Final decision

SP AusNet transmission determination

2008-09 to 2013-14

January 2008

Figure A.1: Risk of CT failure 2003-14

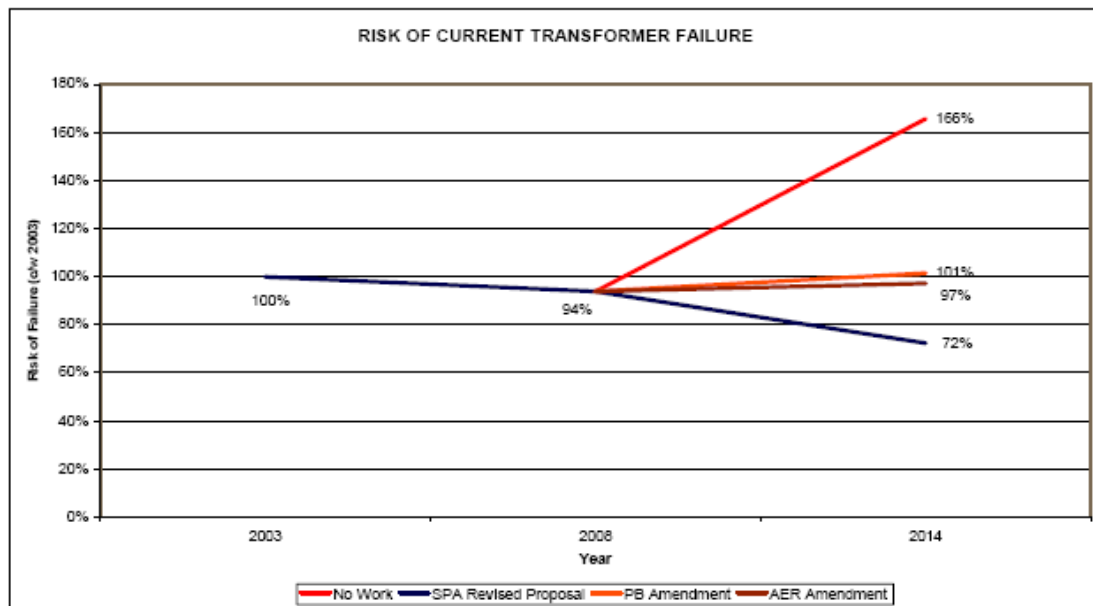
Based on an updated version of its CT failure risk model, SP AusNet has modelled the CT replacements proposed in its revised proposal against those recommended by PB, and those approved in the AER's draft decision. Figure A.1 illustrates the results of SP AusNet's analysis over the period 2003 to 2014.

Figure A.2: Optimum timing of CT replacements

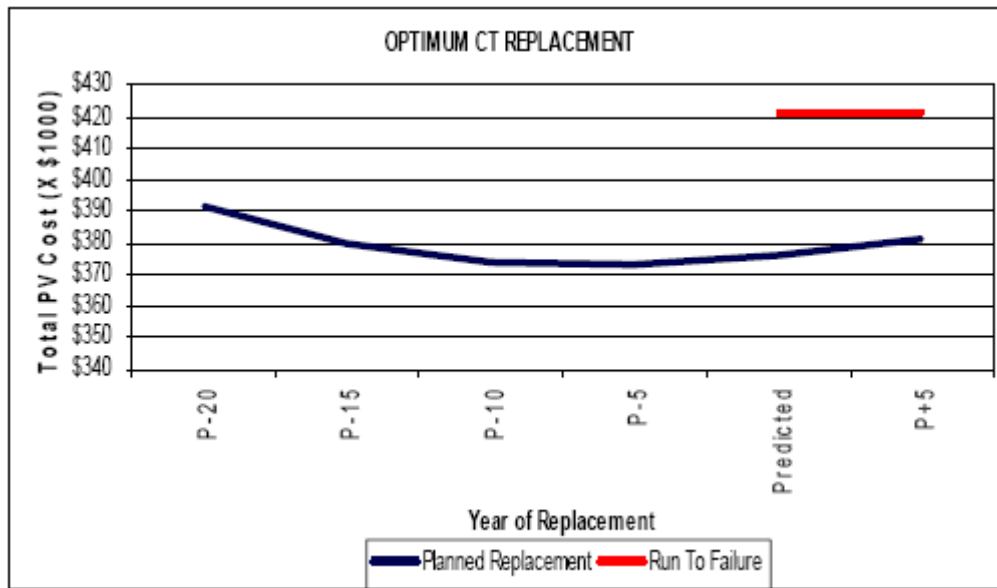
SP AusNet has presented an economic analysis of life cycle costs for a typical CT in its fleet which examines the impact of replacement timing on the relative costs of run-to-failure and planned replacement. SP AusNet submits that, based on the results of its analysis, the efficient timing for planned replacement of CTs is 5 to 10 years prior to predicted failure, as shown in figure A.2.

Figure A.3: NPV of CT replacement programs 2008-14

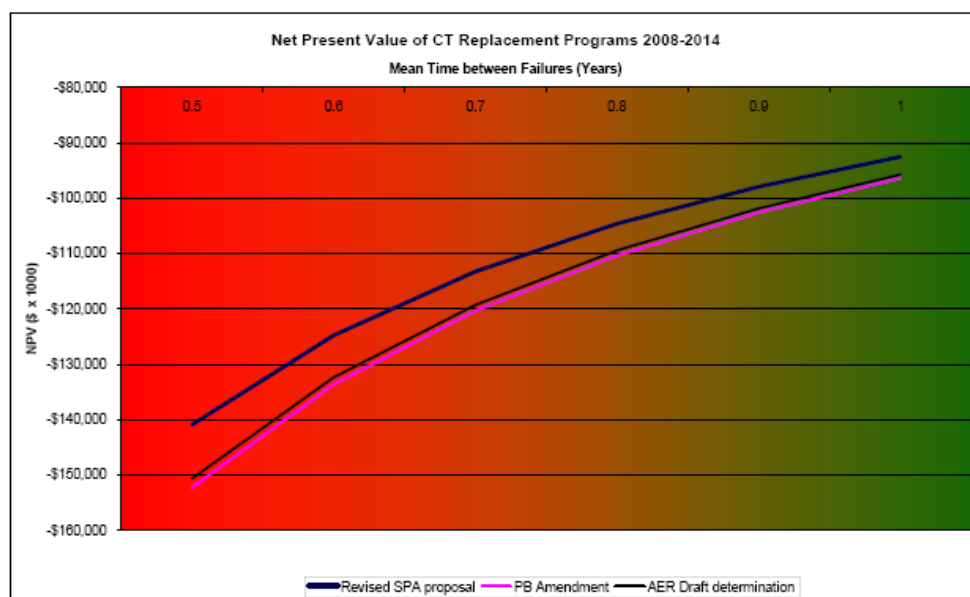
SP AusNet submits that, based on an expectation of at least one CT failure per annum over the forthcoming regulatory control period (i.e. $MTBF \leq 1.0$), its revised proposal represents the least cost option when compared to the positions taken by PB and the AER, as shown in figure A.3.

Figure A.5: Optimum timing of CT replacements – sensitivity to community cost inputs

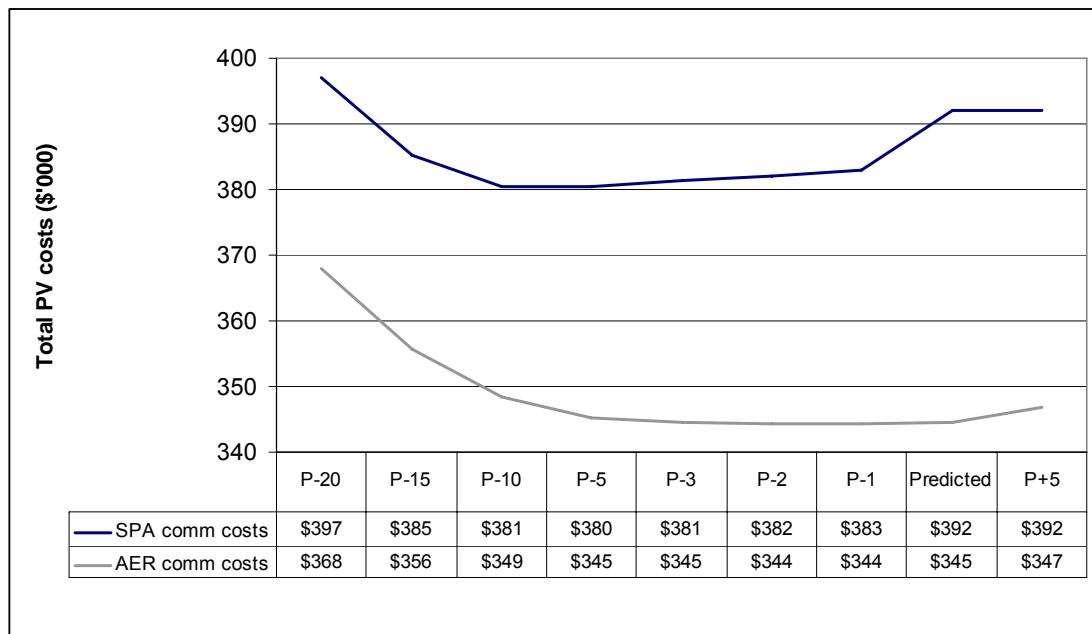
These adjustments to the community cost inputs have a significant impact on the optimum timing for CT replacement. As shown in figure A.5, when the AER's amended community cost inputs are substituted in the model for SP AusNet's overstated community cost inputs, the optimum timing of CT replacements falls from 5-10 years to 1-2 years before predicted life expiry.

Figure A.7: PV analysis of CT replacement programs (AER's amended community costs)

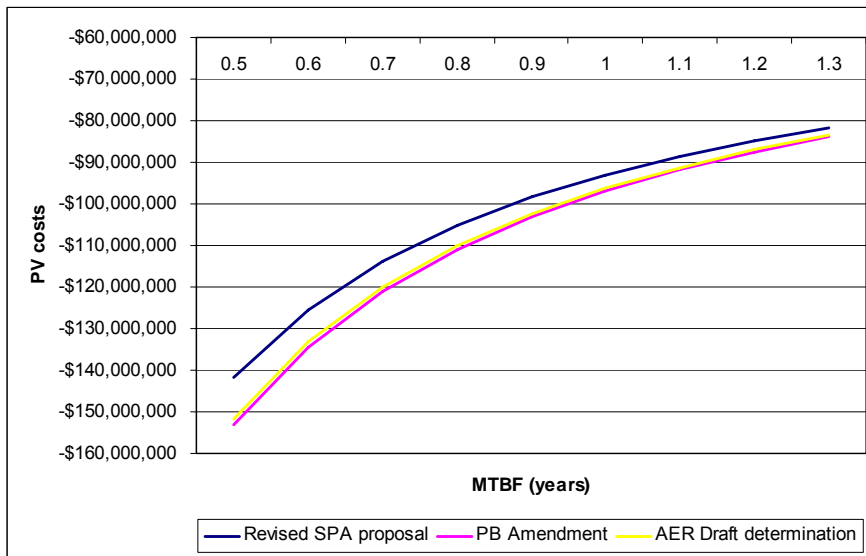
On the basis of the amended community costs and a number of other reasonable assumptions,³³⁷ the AER has re-run SP AusNet's model. Figures A.6 and A.7 illustrate the impact of the AER's input assumptions on the least cost option.

The AER accepts PB's advice that an MTBF assumption of no less than 1 is reasonable. On this basis the AER considers that the result suggested by figure A.7 supports its draft decision position regarding CT replacements as the least cost option (i.e. assuming an $MTBF \geq 0.9$).

Figure A.8: Optimal economic life for an average LG4C CB

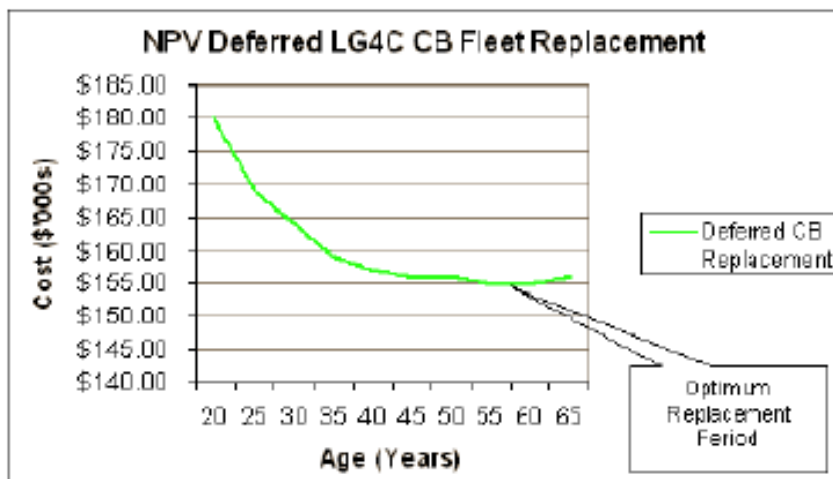
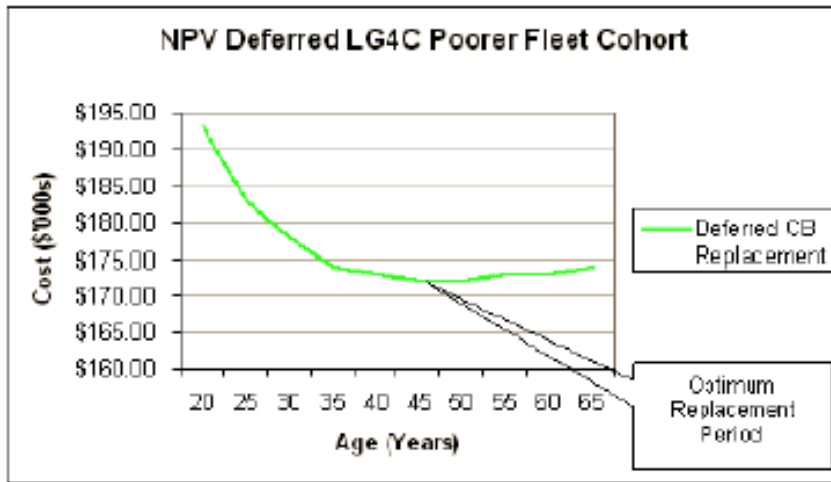
SP AusNet states that it has undertaken some analysis of more recent failures and maintenance data to determine the optimal economic life for an LG4C CB. The results of its analysis indicate that the optimal life for an ‘average’ LG4C CB is 55-60 years, whereas that for an LG4C CB in a ‘poor performing cohort’ is 45-50 years.

The results of SP AusNet’s economic analysis are shown in figures A.8 and A.9.

Figure A.11: Options for 66kV switchyard at GNTS

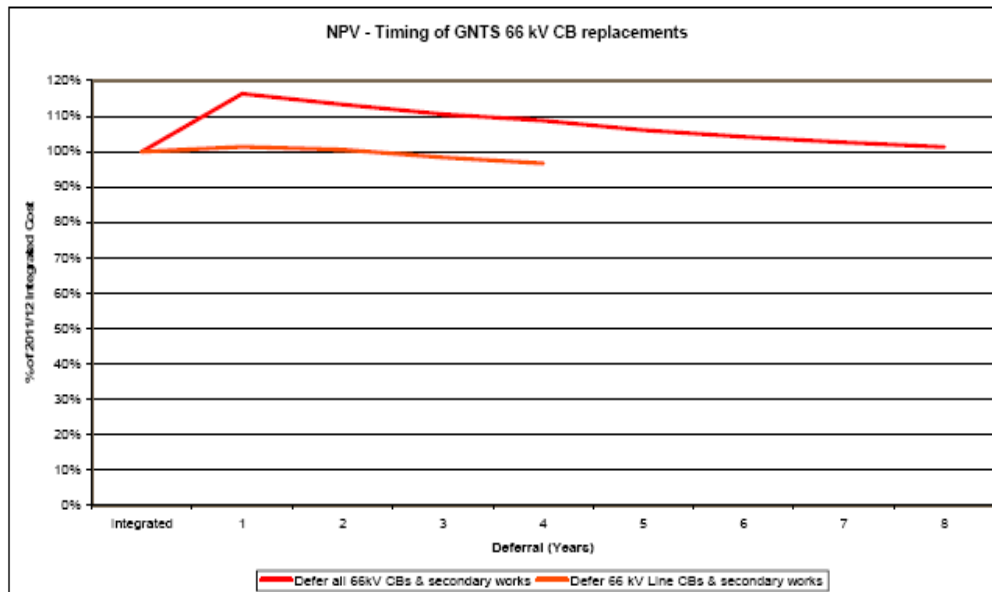
The AER notes that SP AusNet has explicitly captured in its NPV analysis the ‘additional design, construction, testing and commissioning effort’ associated with undertaking the works at GNTS as two discrete projects. It is also noted that the consequences of failure of the CBs at GNTS is included as a cash flow (probability-weighted) in the NPV analysis. The AER does not consider that SP AusNet’s statement that the deferral option ‘does not deliver any meaningful savings’ survives scrutiny. Figure A.11, submitted by SP AusNet in its revised proposal, models the PV costs of the various 66kV deferral options as a percentage of the PV costs of the integrated project option.³⁸⁷

Figure A.11 illustrates two main points:
